ADDENDUM

ADDENDUM NO.: 04
PROJECT NAME: Salt Dome Replacement Facility (Grand Avenue)
PROJECT NO.: 04021
CONTRACT NO.: C1598
DATE OF ISSUE: January 27, 2021

NOTICE OF CHANGES, MODIFICATIONS, OR CLARIFICATIONS TO CONTRACT DOCUMENTS

E1.2

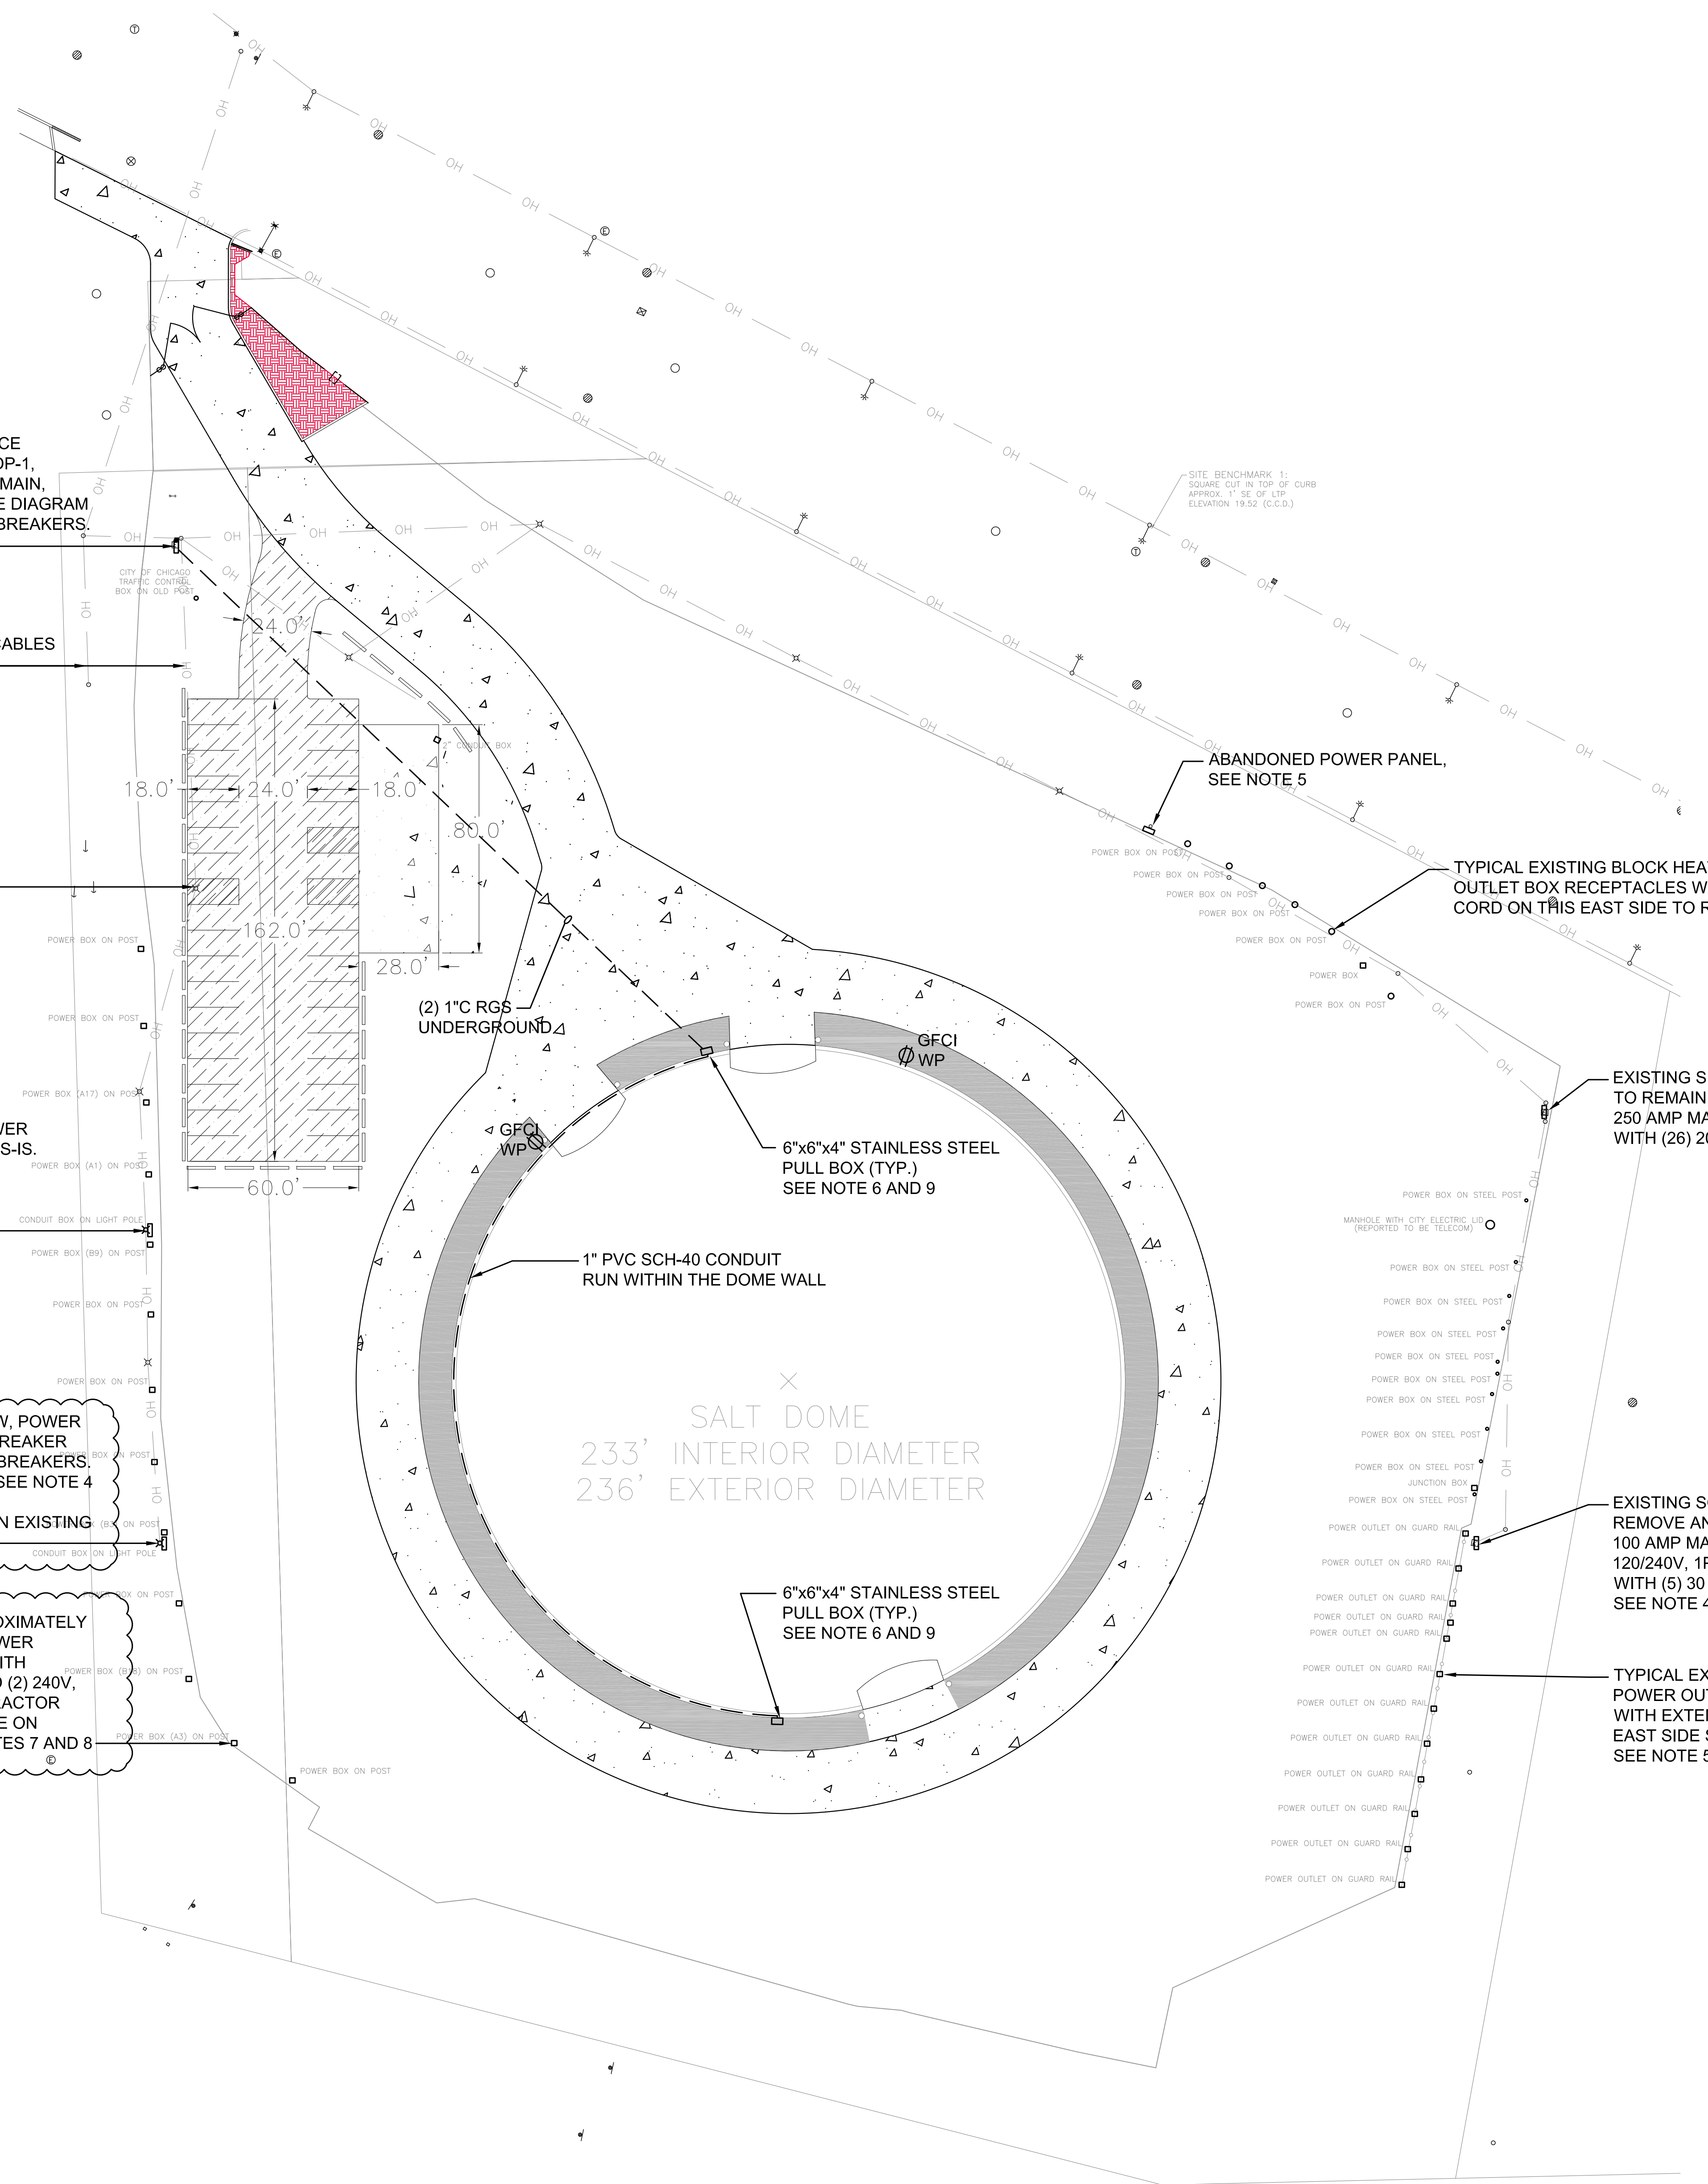
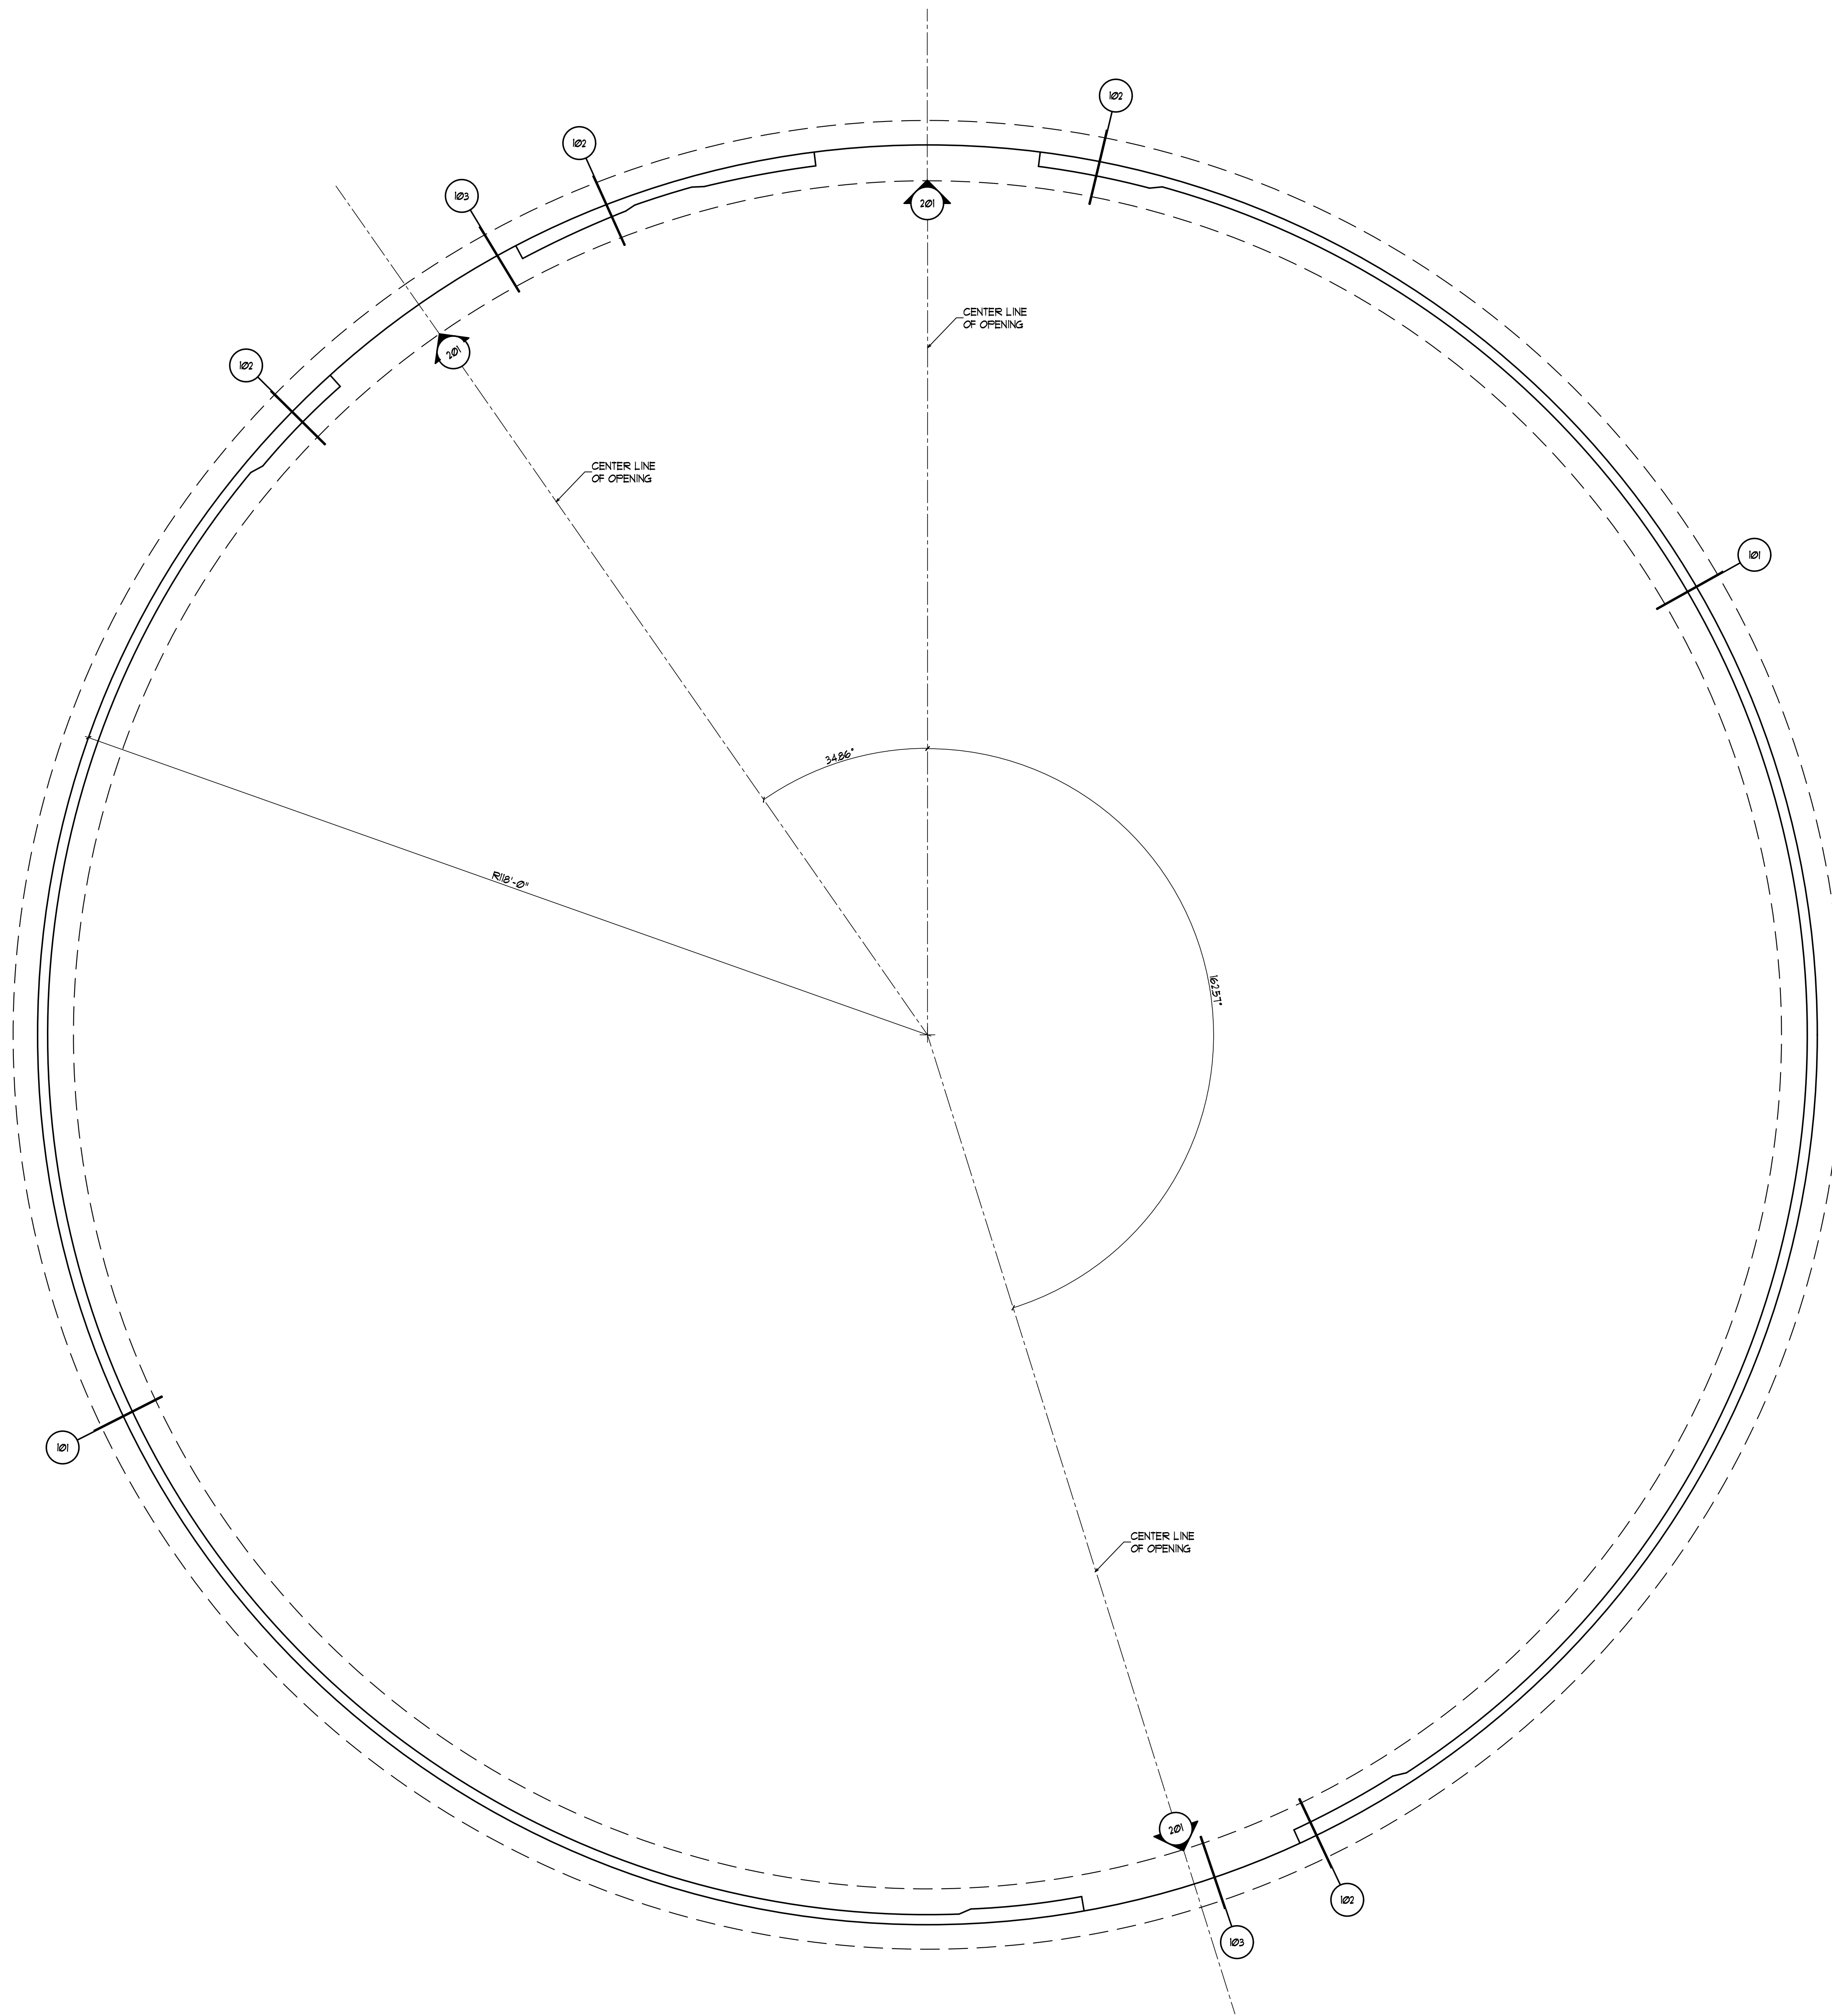
Change 5 **REVISED** Drawing No. E1.2, Site Power Plan: Note 8 and relevant callouts revised for clarity. Sheet scale fixed.

Question: (Electrical E1.2) Per the note regarding the “Yellow Boxes”, page E1.2, is electrical to simply “rotate the boxes to face WEST, or is there more to this relocation effort? Where are the existing boxes currently? The note is slightly ominous in its projection of the work effort, please advise.

Question: (Electrical E1.2) Is Note # 8, Drawing E1.2 referring to the “Yellow Boxes”? See below.
8. CONTRACTOR TO REPLACE HUBBELL POWER BOXES, DETAIL "C" AND "D" WITH APPLETON UNILET SINGLE COVER FOR GFCI FSCD BOX. PROVIDE COMPLETE ASSEMBLY 240V, 20AMP DISCONNECT SWITCH, NEMA 6-20R CONFIGURATION RECEPTACLE AND PLUG AND CABLE ASSEMBLY WITH FEMALE PLUG, FOR EACH HUBBELL POWER BOX, CONTRACTOR TO INSTALL TWO APPLETON UNILET FSCD BOXES, SEE DETAILS "E" AND "F" ON SHEET E1.3.

- There are discrepancies with the notes on E1.2. Please confirm the scope of work with all Hubbell boxes on the east side of the salt dome.
- Please clarify the correct spaces in the 100A panels to be replaced. (30? 42?)
- Please clarify if the 30A breakers requested on the print are single pole or 2 pole.

Question: Reference: Electrical - There is a note on the lower left corner of E1.2 that says we are to replace 13 Hubbell 240V Power Boxes with 2 pole breakers. It looks like Note 7 and 8 apply to this replacement. Note 8 refers to E1.3 Detail E, which shows a 120V device. Is the intent to replace the 240V Hubbell boxes and have them feed 2 Nema 6-20R receptacles mounted similar to E1.3 detail E? Are GFI breakers required in the Hubbell boxes?

Response: Drawing sheet E1.2 has been revised and included in this Addendum. Per Note #8, "Contractor to replace Hubbell Power Boxes, Detail "C" and "D" with Appleton Unilet Single Cover For GFCI FSCD Box".

Response: Drawing sheet E1.2 has been revised and included in this addendum. Note #8 refers to the yellow boxes as shown in Details "C" and "D".

Response: Drawing E1.2 has been revised and included in this addendum -A total of 13 Hubbell boxes are being replaced on the WEST side of the dome as shown on Sheet E1.2. None are being replaced on the east side of the dome.

Response: Drawing Sheet E1.2 note #8 has been revised and included in this addendum to clarify the design intent. Hubbell boxes should be replaced with Appleton unilet cover FSCD box, completely assembled (2) 240V 30amp breakers or disconnect switch and NEMA 6-30R configuration, 30A GFI receptacle plug and cable assembly. Note 7 and 8 have been revised and apply to this replacement. Detail E on sheet 1.3 is shown for reference only.
